OBJECTION TO
DEVELOPMENT AT 241-249 WHEAT RD, COCKLE BAY

PRESENTED TO

The Independent Planning Commission Panel comprising

**PHOTOMONTAGES FROM THE EIS ILLUSTRATING
THE DOMINANCE OF THE TOWER BUILDING
OVER THE BRIDGE**

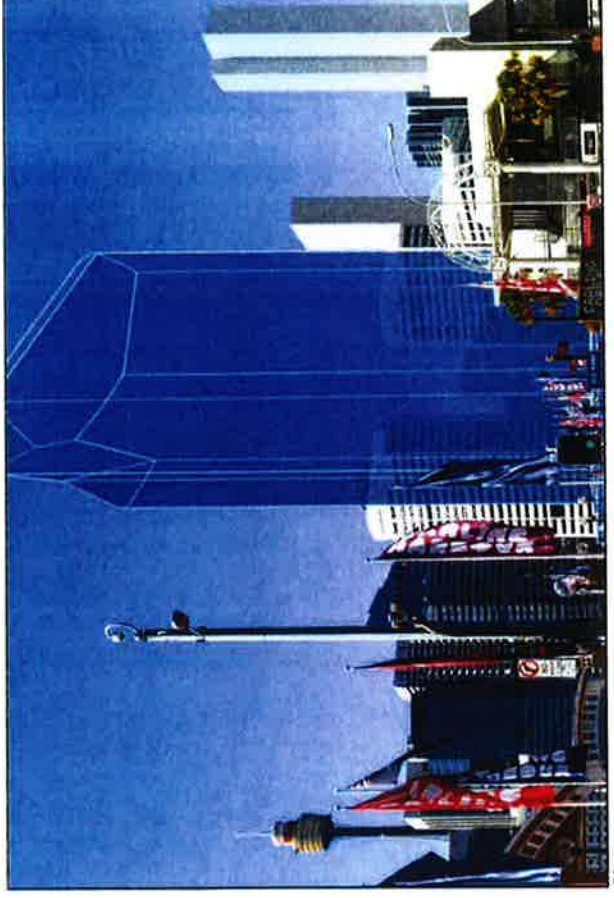
Attached as Appendix I are images included in the E.I.S. illustrating the impact of the proposed tower on the context of Pyrmont Bridge. How it can be said that the tower will complement the heritage of the Bridge is difficult to understand. The reduction in height proposed in the revised DA does not, to any degree, overcome the height problem.

Appendix I and II clearly illustrate the inappropriateness of the proposed tower building in the context of Pyrmont Bridge and of the central Sydney location.

**PHOTOMONTAGES FROM THE EIS ILLUSTRATING
THE RELATIONSHIP OF THE TOWER BUILDING
WITH PYRMONT BRIDGE,
THE WATERS OF DARLING HARBOUR AND THE
EXISTING DARLING PARK BUILDINGS**

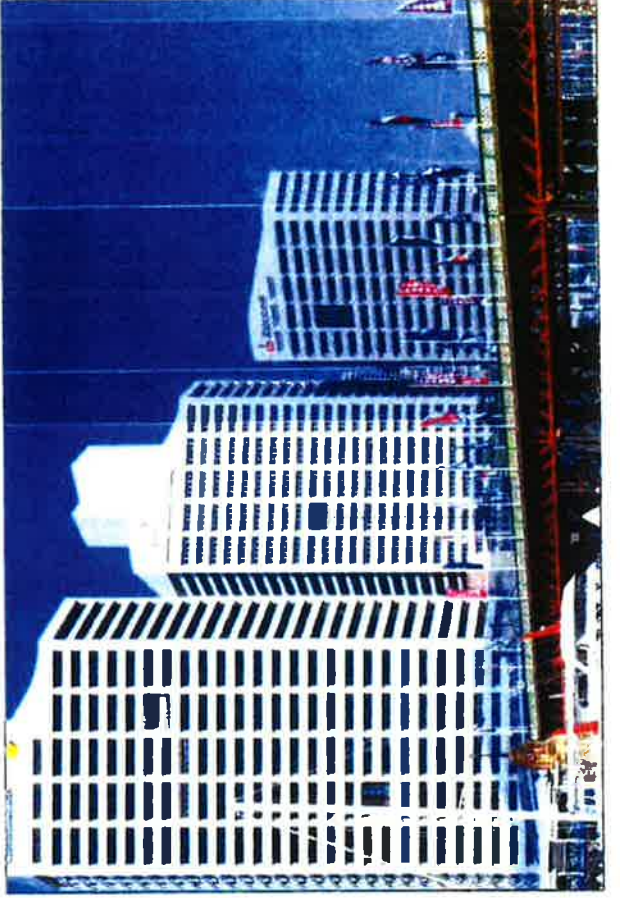
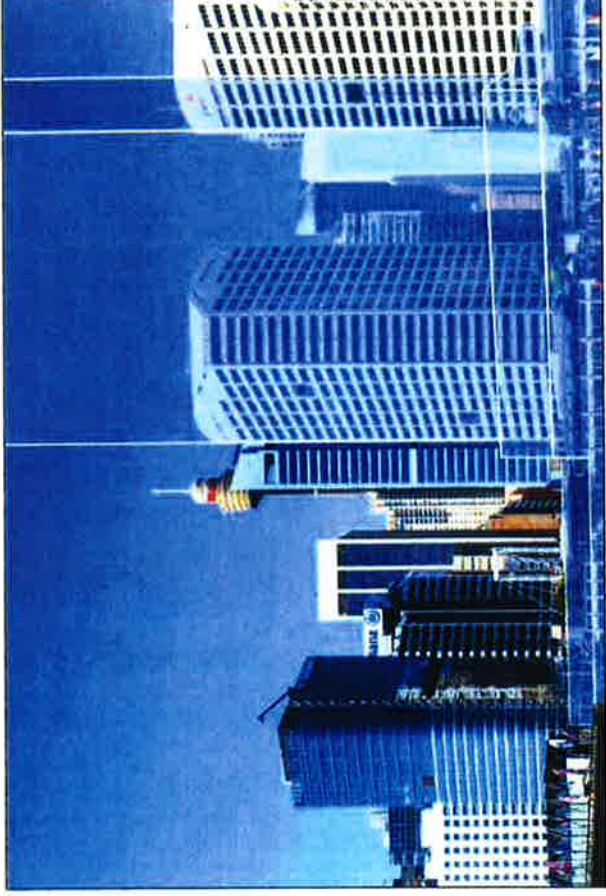
Attached as Appendix II are images included in the E.I.S. illustrating the relationship between the tower building and Pyrmont Bridge, together with the relationship with the existing Darling Park buildings and the proximity to the exceptional heritage qualities of Darling Harbour. The images illustrate the uncharacteristic height and bulk of the proposal to Cockle Bay.

The proposed tower building turning its back on this principle may be graphically seen from the photomontages forming Appendix I and II.
